TECHNICAL BULLETIN

Updated 20 Sept 2021

BOSCH GEN4 SPIDER ASSEMBLY GUARD CHANGE

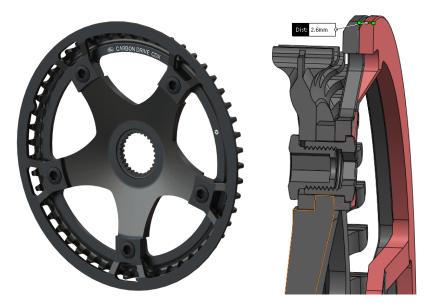
For specific assemblies, Gates will now utilize a guard with less offset, narrowing the overall package by 2.6mm, allowing more clearance for cosmetic and functional covers.

The guard shown in red will be replaced with a narrower guard, adding 2.6mm of outboard clearance.
